**ADDENDUM NO. 2  
10/28/22**

**SPECIFICATION NO. 22-11418-C**

**CITY OF BERKELEY**

**OHLONE PARK (EAST) PLAYGROUND REPLACEMENTS AND SITE IMPROVEMENTS**

PLAN 8261  
 FILE 406-219  
**I-51**  
 SHEET 29 OF 40

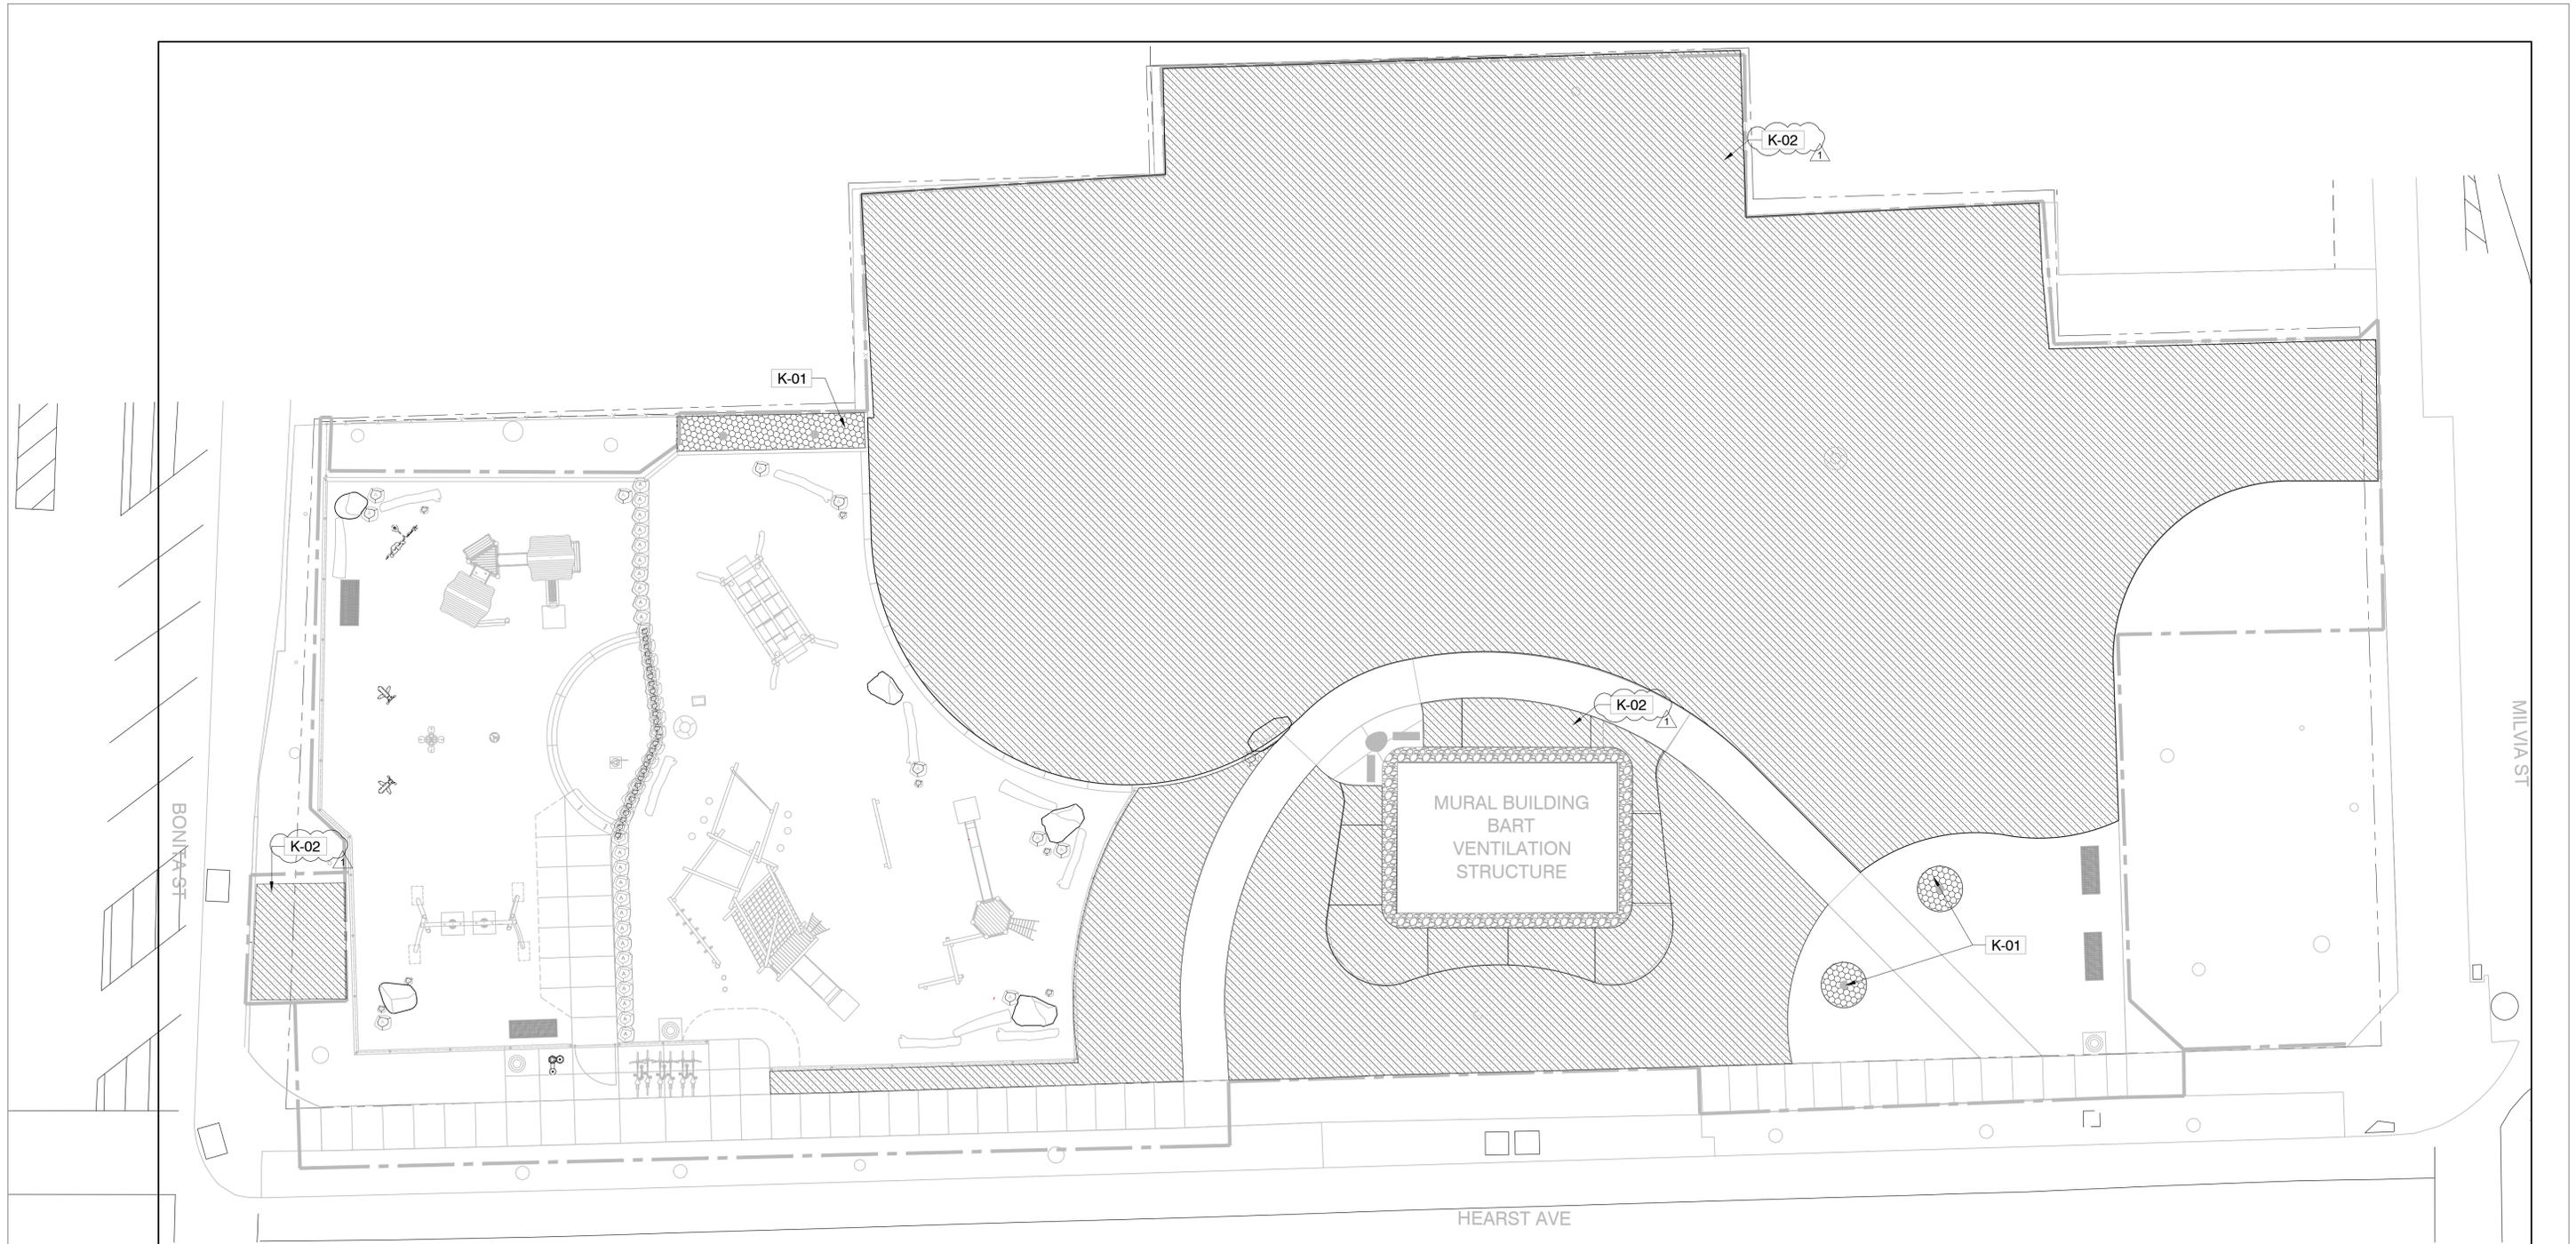
28. Refer to sheet I-5.1, note 12 shows "install two control wires along the entire wire routing for each controller". Since the existing irrigation controller is a conventional system, please advise the purpose of this requirement.

Response This note is not applicable to this project and has been deleted.
